# **A Review and Critical Analysis of Hydrogeological Aspects of the Proposed Central Pickering Development Plan**

## **Final Report**

### **Central Pickering Development Plan**

**August 10th, 2005**

Figure 5. Long-term, steady state chloride concentrations in the Upper Aquifer as a result of road salt application, prior to urban development in the PCPDP study area (shown by yellow line). Predictions were generated using Modflow.

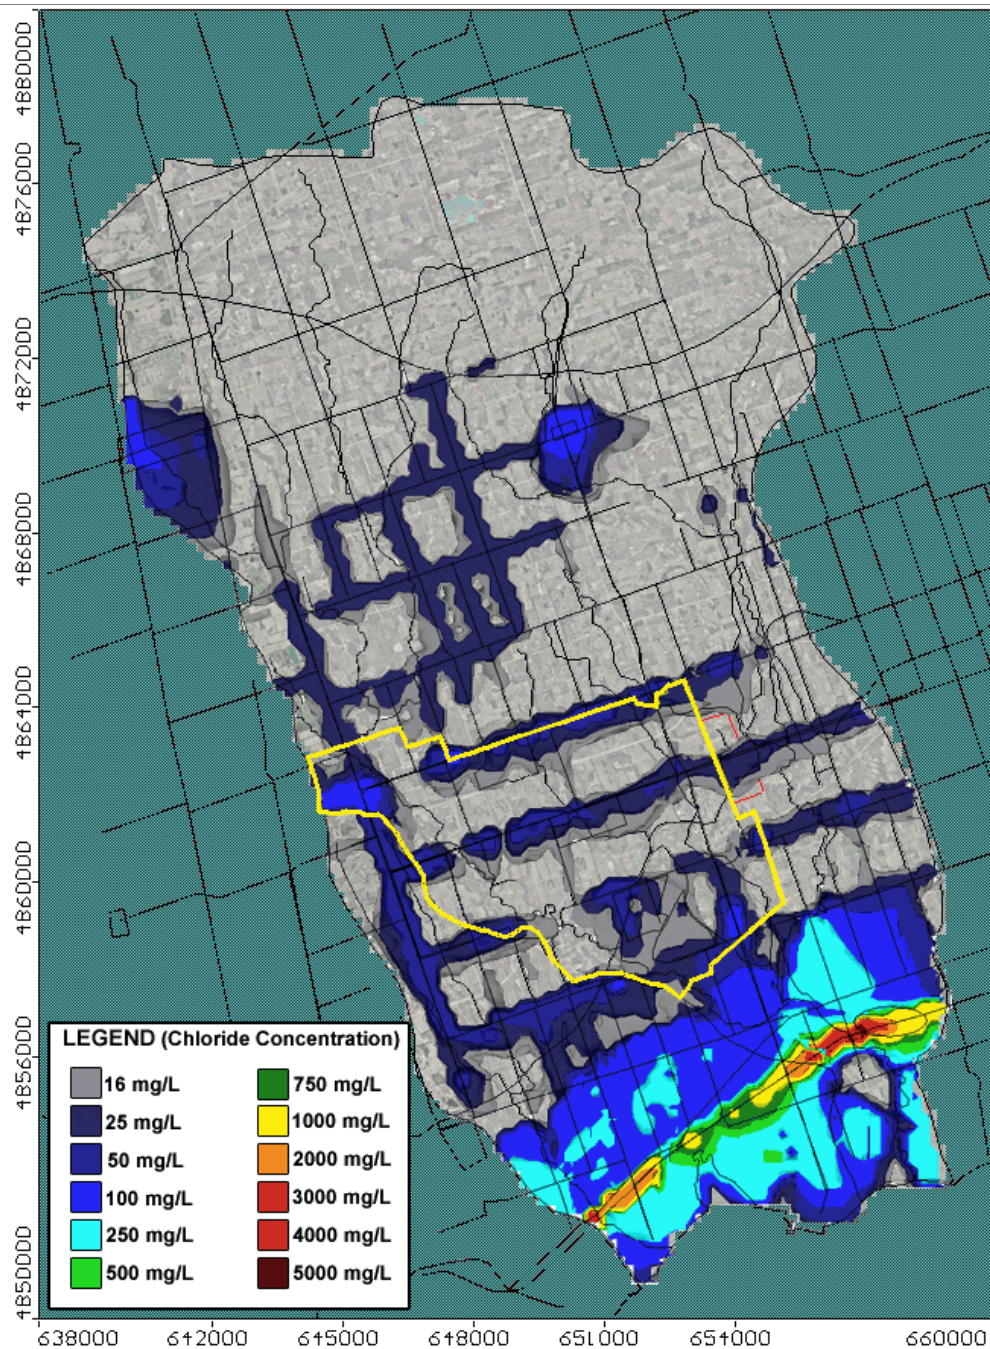
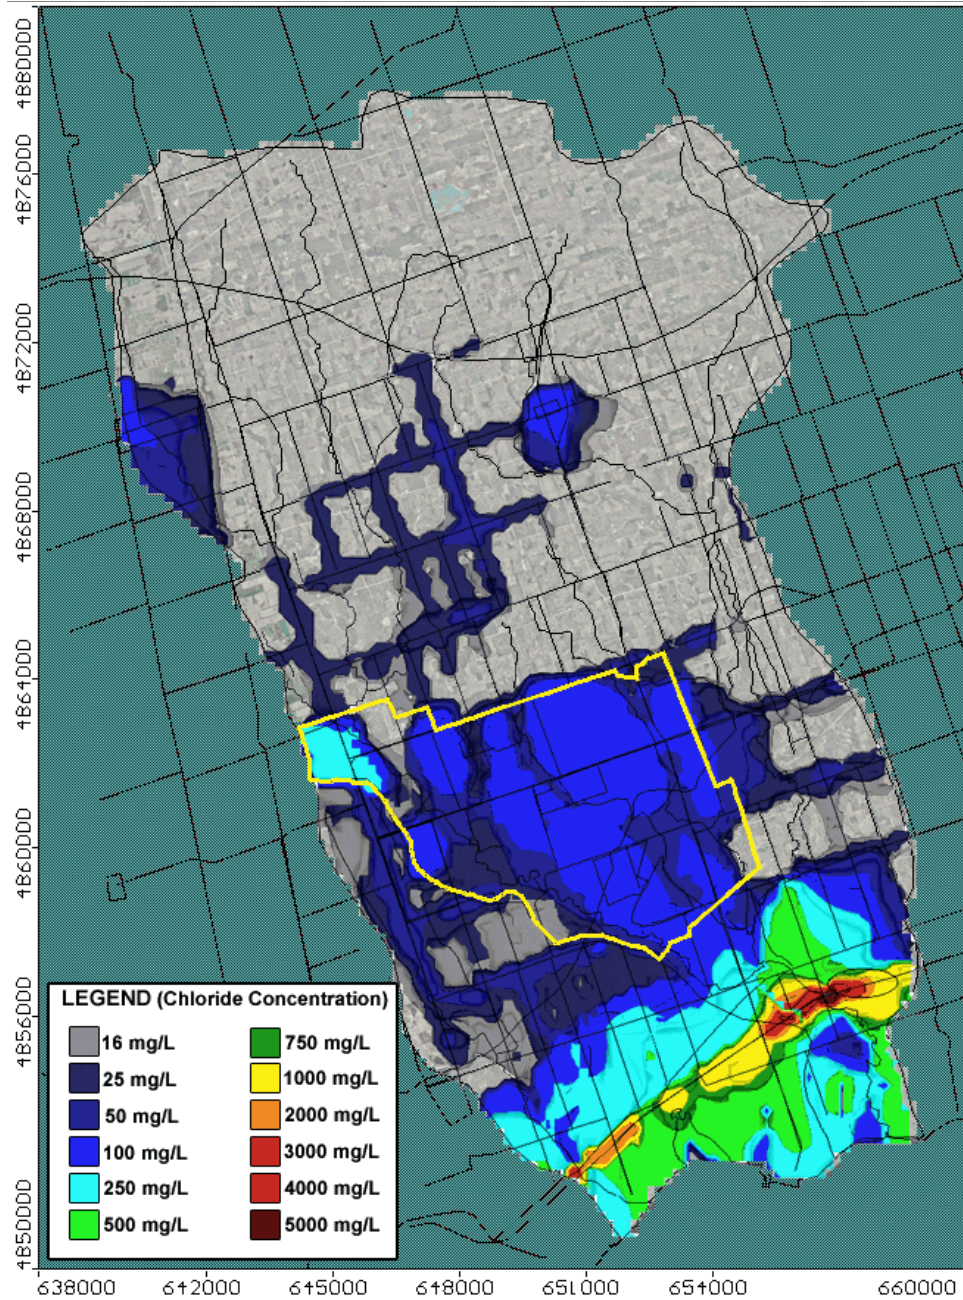
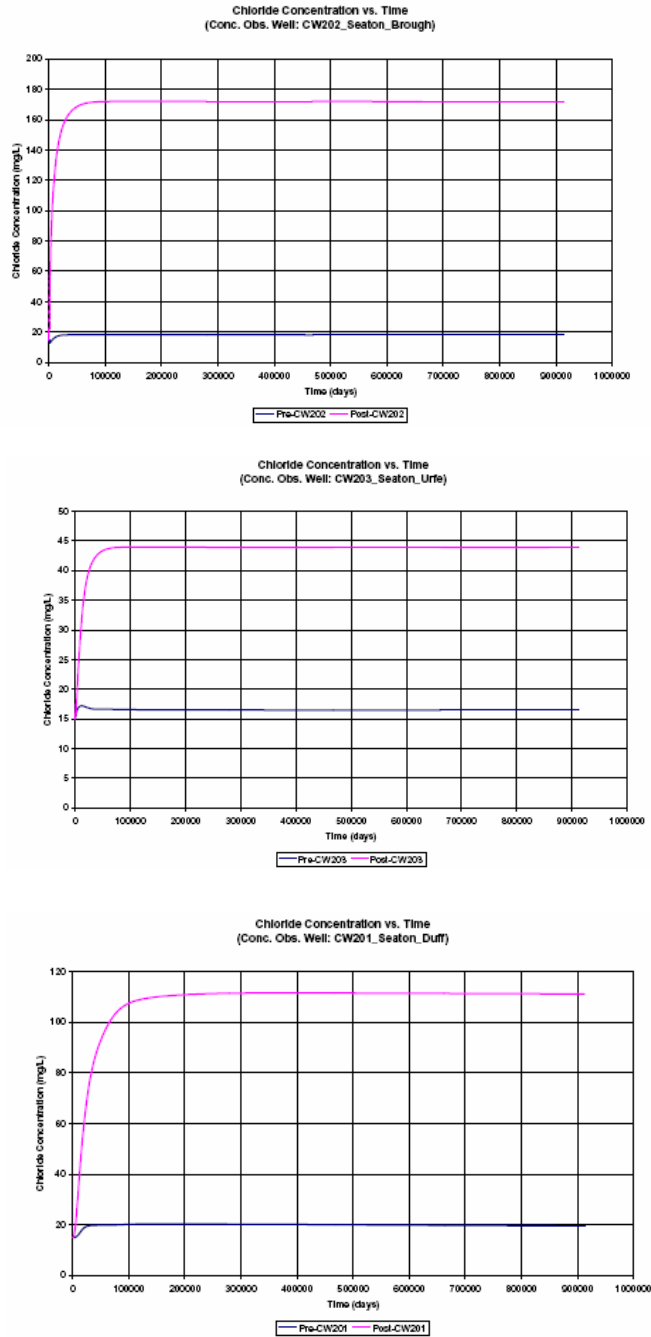
An example of the benefits of the modeling approach is shown in Figures 5, 6 and 7 (Howard and Maier, 2006, in press). Figure 5 shows the predicted long-term impacts of salt application in the Duffins Creek watershed prior to any development on the PCPDP lands. Contours shown represent predicted chloride concentrations in the Upper Aquifer when chemical steady state is reached. Figure 6 shows predicted long-term chloride concentrations following urban development, while Figure 7 demonstrates how chloride changes with time in 3 randomly selected observation wells. Models such as these can be developed for a whole range of land use scenarios and mitigation measures within the PCPDP study area, with adjustments made to the development plan until impacts fall within acceptable levels.
